Product Change Notification / LIAL-24K0XB344

CCB 4477 Final Notice Implement additional cover tape, carrier tape and plastic reel material supplier for selected Micrel products available in 3L, 5L, 6L and 8L SOT23, 5L and 6L TSOP and 8L SOIC packages at STAR assembly site.

Cover Tape for SOT23-3/5/6/8L , TSOT-5L/6L

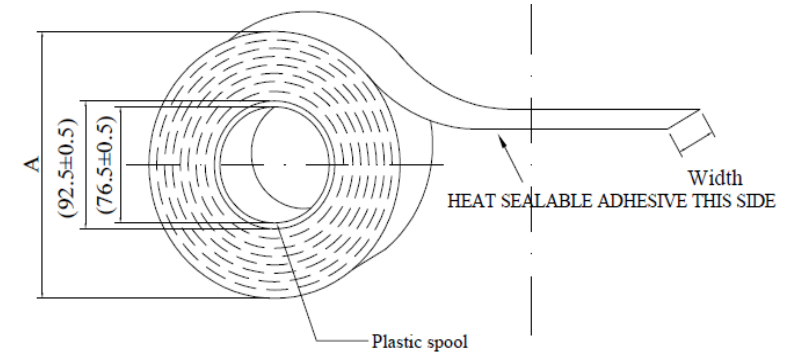
Static Dissipative Heat Activated Cover Tape 2675 Standard Width
"A" (mm)
5.4 ± 0.1

Supplier	Supplier Mfg. part no.	Carrier width (mm)	Cover tape Width "W" (mm)	Thickness (mm)	Sealing Methodology
CPAK	CP38-054A,5.4 mm	8.4	5.4 ± 0.1 mm	0.055 ± 0.01mm	Heat Seal
3M	2675,5.4 mm	8.4	5.4 ± 0.1 mm	0.062 ± 0.013mm	Heat Seal
U-PAK	UP-175-054	8.4	5.4 ± 0.1 mm	0.048 ± 0.050mm	Heat Seal

Carrier Tape for SOIC8L

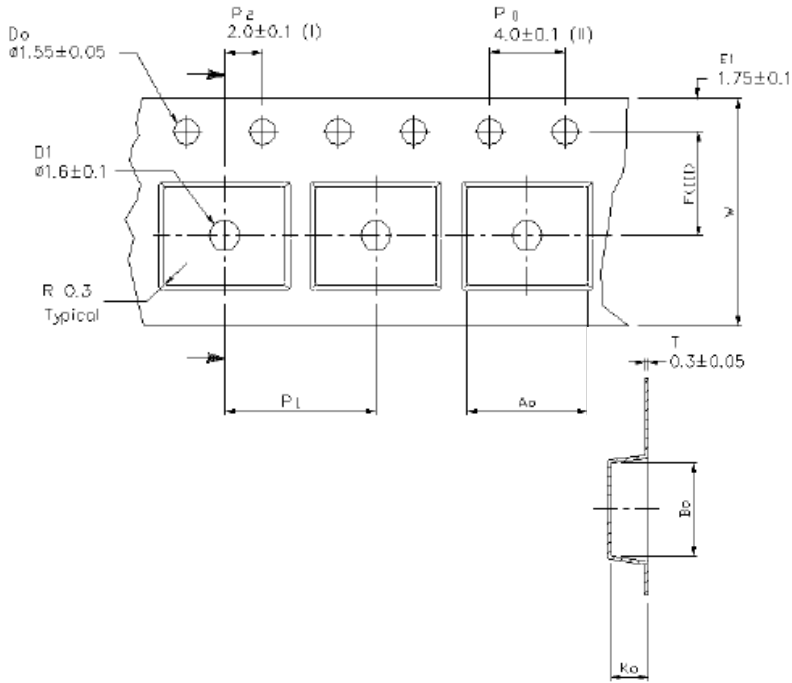
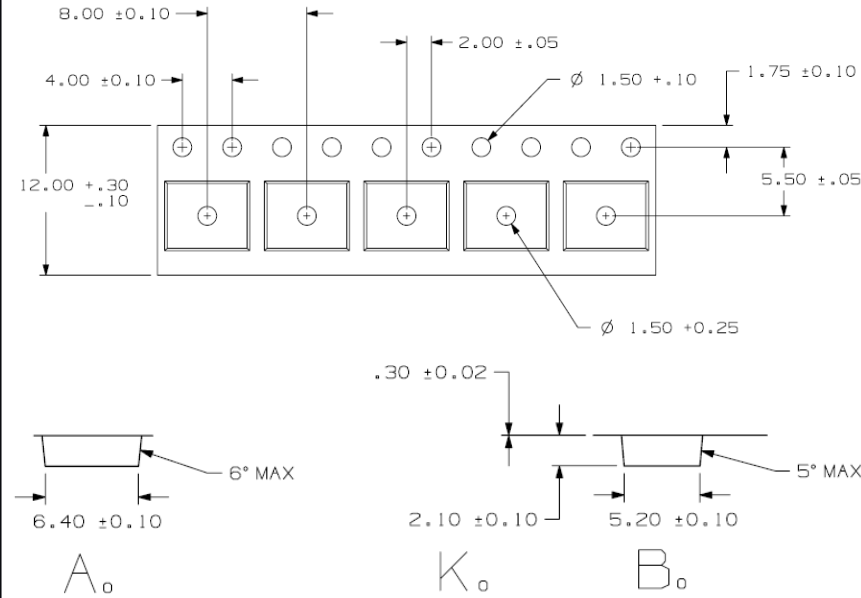
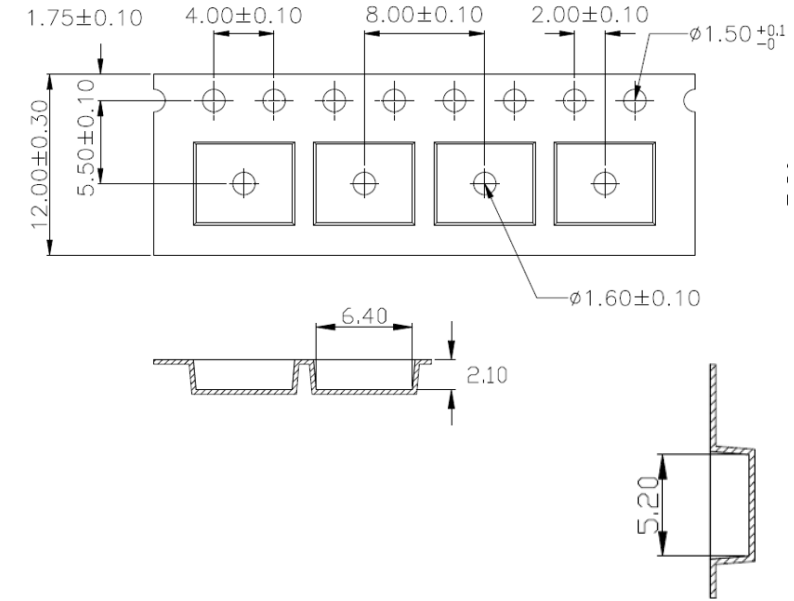
Carrier Tape Supplier	Supplier Mfg. part no.	Width (mm)	Pitch (mm)	A0 (mm)	B0 (mm)	K0 (mm)	Thickness (mm)
CPAK	CPD-092A	12.00 ± 0.100	8.00 ± 0.100	6.40 ± 0.10	5.20 ± 0.10	2.10 ± 0.10	0.30 ± 0.05
3M	TWO13611-4	12.00 +0.30/-0.10	8.00 ± 0.100	6.40 ± 0.10	5.20 ± 0.10	2.10 ± 0.10	0.30 ± 0.02
U-PAK	UPKSOIC08A-SMS	12.00 ± 0.100	8.00 ± 0.100	6.40 ± 0.10	5.20 ± 0.10	2.10 ± 0.10	0.30 ± 0.05

Cover Tape for SOIC8L

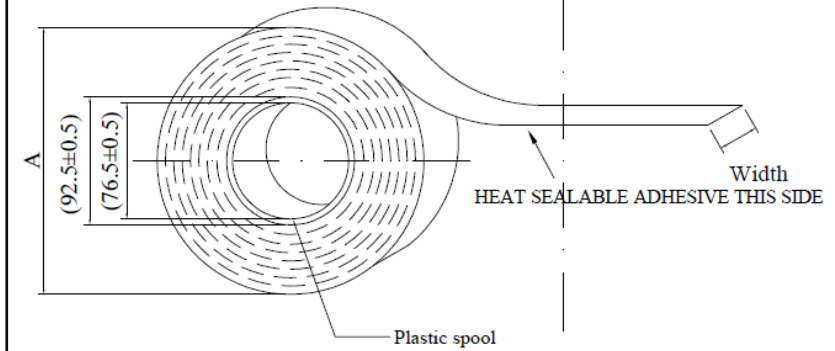
Static Dissipative Heat Activated Cover Tape 2675 Standard Width
"A" (mm)
9.3 ± 0.1

Supplier	Supplier Mfg. part no.	Carrier width (mm)	Cover tape Width "W" (mm)	Thickness (mm)	Sealing Methodology
CPAK	CP38-054A, 5.4 mm	12	9.2 ± 0.1 mm	0.056 ± 0.005mm	Heat Seal
3M	2675, 9.3 mm	12	9.3 ± 0.1 mm	0.062 ± 0.013mm	Heat Seal
U-PAK	UP-175-093	12	9.3 ± 0.1 mm	0.048 ± 0.050mm	Heat Seal
